## Draft EA Comments and Responses to Comments

## Appendix N Draft EA Comments and Responses to Comments

Airfield Improvements and Terminal 1 Replacement Project  
July 2021 Draft Environmental Assessment

### **Illegal nighttime noise abatement agreement**

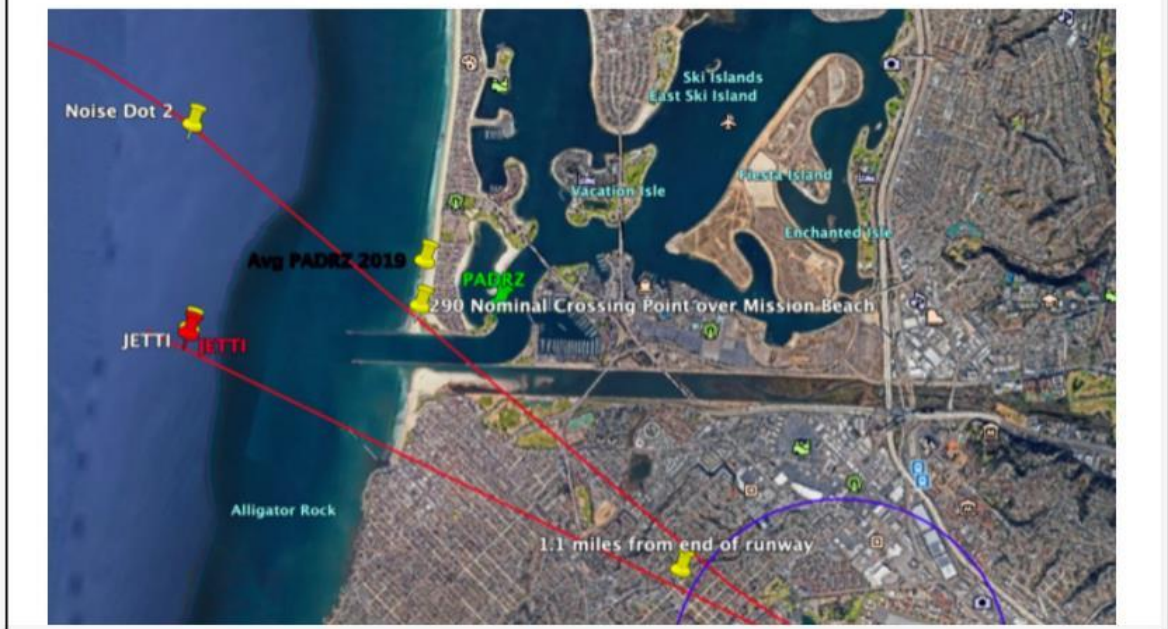
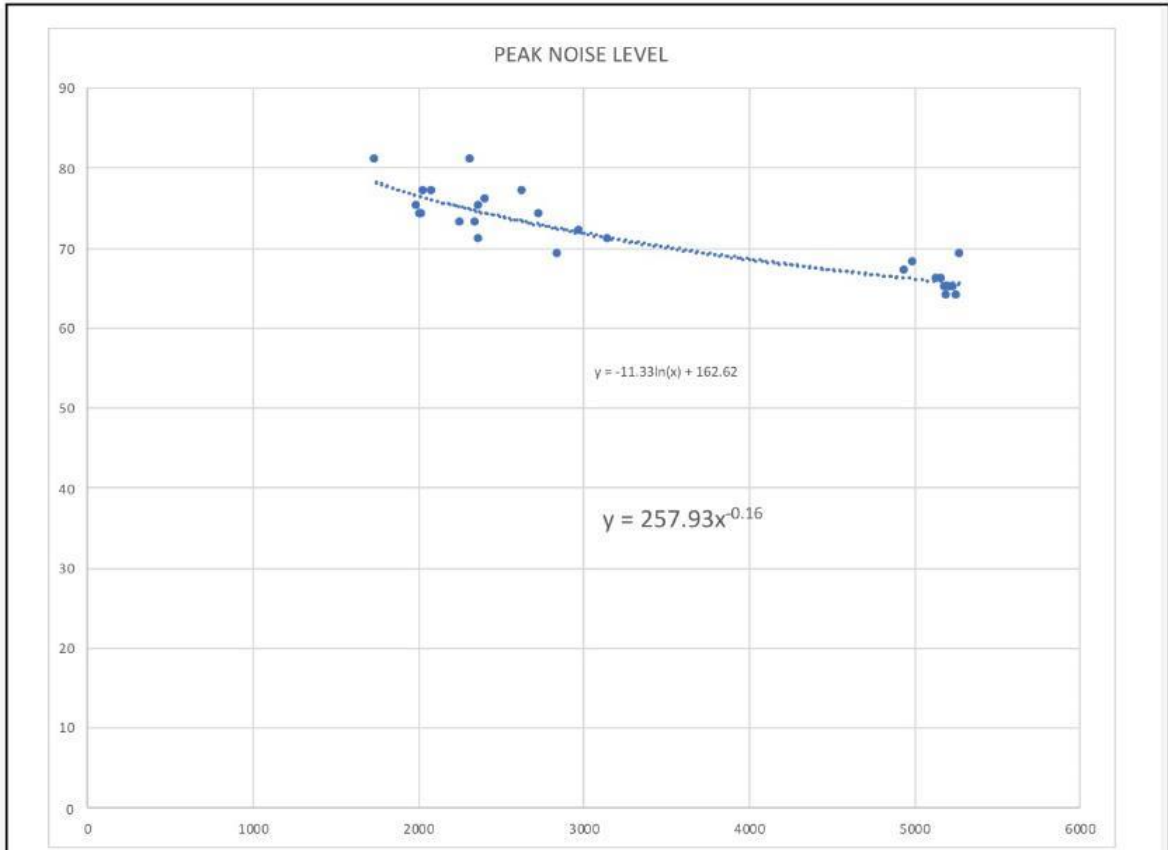
2. The Airport Authority continues to ignore the illegal post 10 pm departure, referred to as the nighttime noise abatement departure. The change was illegal when it was implemented decades ago and it is still illegal for the same reason. There was never an environmental assessment to quantify the noise shift on Mission Beach. This assessment must be made to confirm "no shift".	2
--	---

There is general consensus that the post 10 pm departures were moved from the 275 degree departure, now referred to as the ZZOOO departure, to a vector departure of 290 degrees, without any environmental assessment. Multiple searches at the FAA have confirmed that there are no documents associated with this move. Consultants working for the Airport Authority refer to this departure as unapproved by the FAA.

P1-2. Comment noted. The existing nighttime curfew, enacted prior to the 1990 Airport Noise and Capacity Act and, thus, grandfathered, that affects departures between 11:30 p.m. and 6:30 a.m. would not be affected by the Proposed Project. As the curfew would not be affected by the Proposed Project, further considerations of it are outside the scope of this EA.
